Attachment B – Proposed Consent Conditions

Updated 13 September 2024; Tracked Changes Version

Water permit (Section 14 RMA)

Figure 1: Key Features of the Manapouri Lake Control Improvement Project

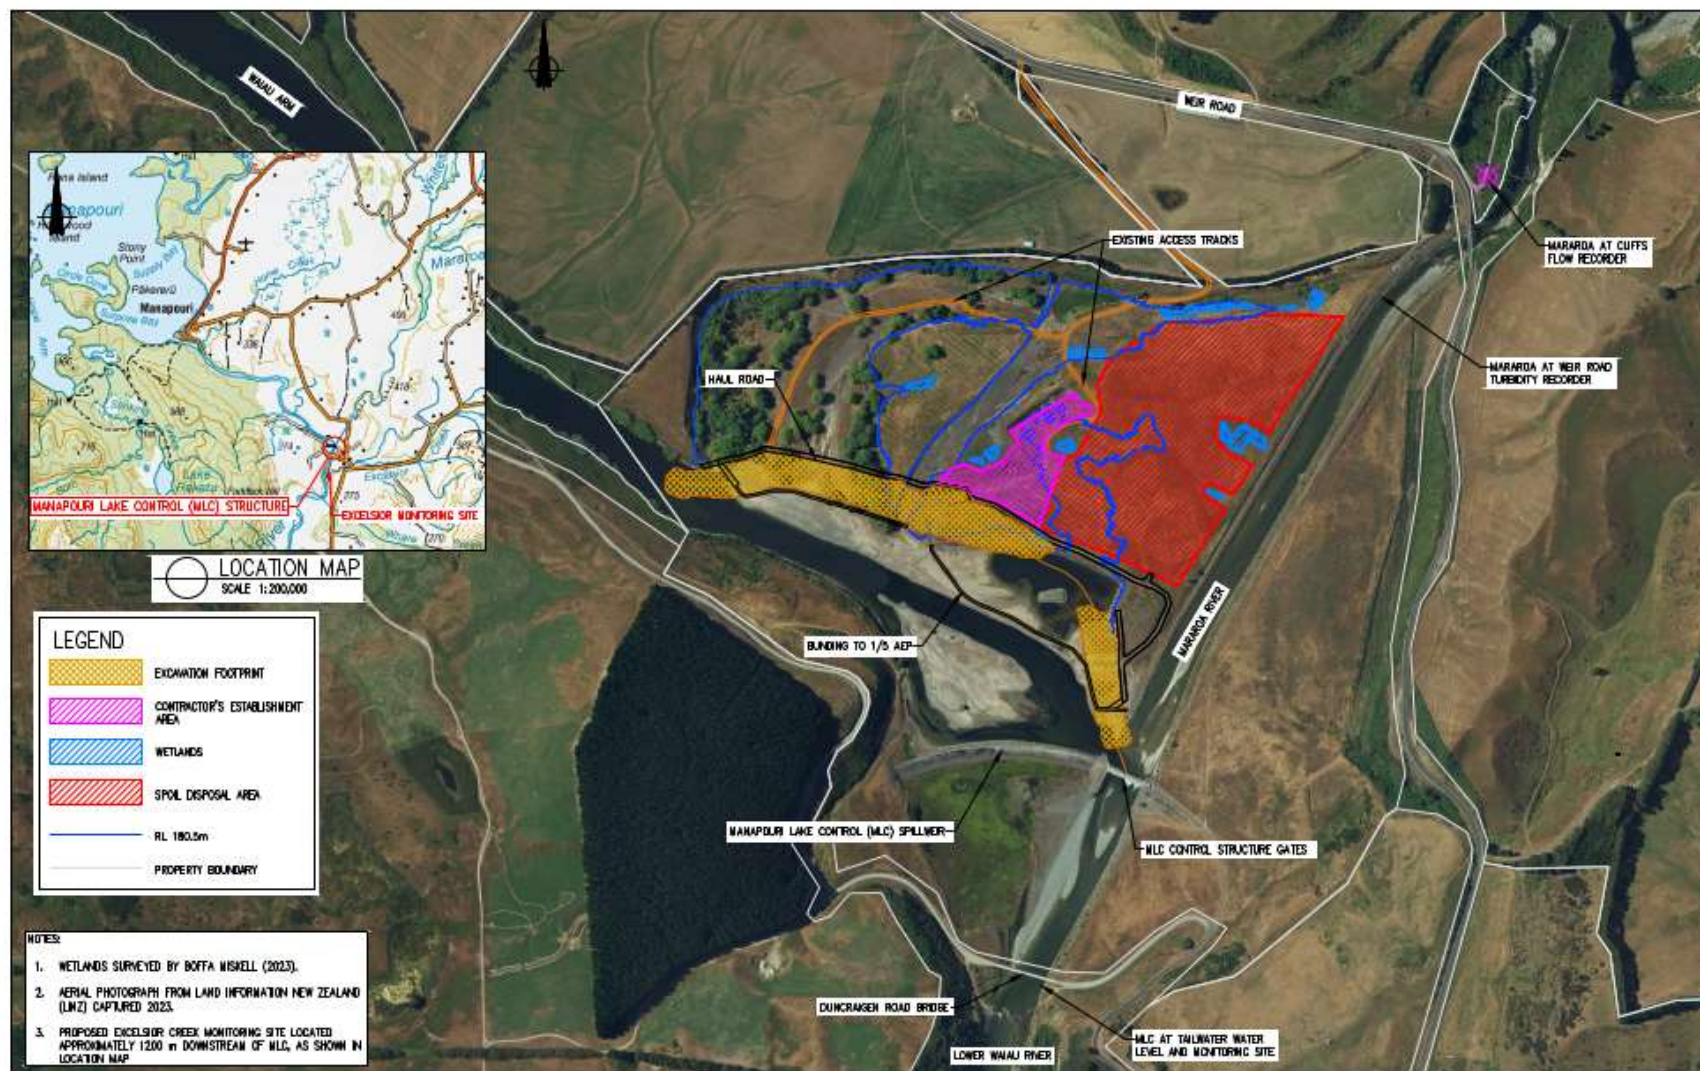
2.	<p><u>This resource consent authorises the take, use, and diversion of water as required to construct, operate and maintain the Manapōuri Lake Control Improvement Project at or about map reference NZTM E1186072 N4935093 and as shown on Figure 1 attached to and forming part of this consent. The activities authorised under this consent are:</u></p> <p><u>Construction works</u></p>	Condition updated to more clearly delineate construction works and operational/ maintenance activities, and provide greater specificity around the authorised works.

2.	<p><u>This resource consent authorises the discharge of water and sediment to water, and to land in circumstances where it may enter water, as required to construct, operate and maintain the Manapōuri Lake Control Improvement Project at or about map reference NZTM E1186072 N4935093 and as shown on Figure 1 attached to and forming part of this consent. The activities authorised under this resource consent are:</u></p> <p><u>Construction works</u></p> <p><u>a. Discharge suspended sediment to surface water from the disturbance and excavation of the bed of the Waiau Arm and riparian margins during parallel channel excavation activities; and</u></p> <p><u>b. Discharge water and sediment to land, in circumstances where it may enter water, from development of (and where relevant, disestablishment and/or rehabilitation of) the Contractor’s Establishment Area, Spoil Disposal Area, haul road, bunding, drainage features, erosion and sediment control measures, dewatering, and dust suppression activities.</u></p>	<p>Condition updated to more clearly delineate construction works and operational/ maintenance activities, and provide greater specificity around the authorised works.</p> <p>Activities subject to MTADA are intentionally omitted from this description.</p>

5.	<p>In the conditions of this resource consent:</p> <p>a. “Parallel channel excavation works” means the construction of the parallel channel.</p> <p>b. “Maintenance activities” means those activities, including removal of gravel and bed material, as necessary to maintain the parallel channel, and the existing channels of the Waiau Arm upstream of and around the confluence with the Mararoa River at MLC, in general accordance with their constructed dimensions.</p> <p>c. “Duration of the parallel channel excavation works” means from the commencement of excavation works in the parallel channel to the conclusion of excavation works on the parallel channel including a period ending 5 days (120 hours) after the parallel channel is made fully open to the Waiau Arm.</p> <p>d. The “upstream monitoring site” (UMS) means the existing site monitored by Meridian Energy Limited in the Maraora River at the Cliffs <u>at or about map reference NZTM E1186690 N4935750 and as shown on Figure 1 attached to and forming part of this resource consent [map reference TBC — as per Figure 5.5 of this AEE],</u></p> <p>e. The “downstream monitoring site” (DMS) means the existing site monitored by the Southland Regional Council upstream of the confluence of the Excelsior Stream with the Lower Waiau</p>	Map references for the monitoring sites now included, noting these sites are also labelled on Figure 1 which is proposed to be included in the consent documents.

20.	Any future removal of gravel from the spoil disposal area shall be limited to within the defined 'gravel stockpile cell' as shown on map X in Appendix X Figure 1 attached to and forming part of	Figure cross-reference updated.
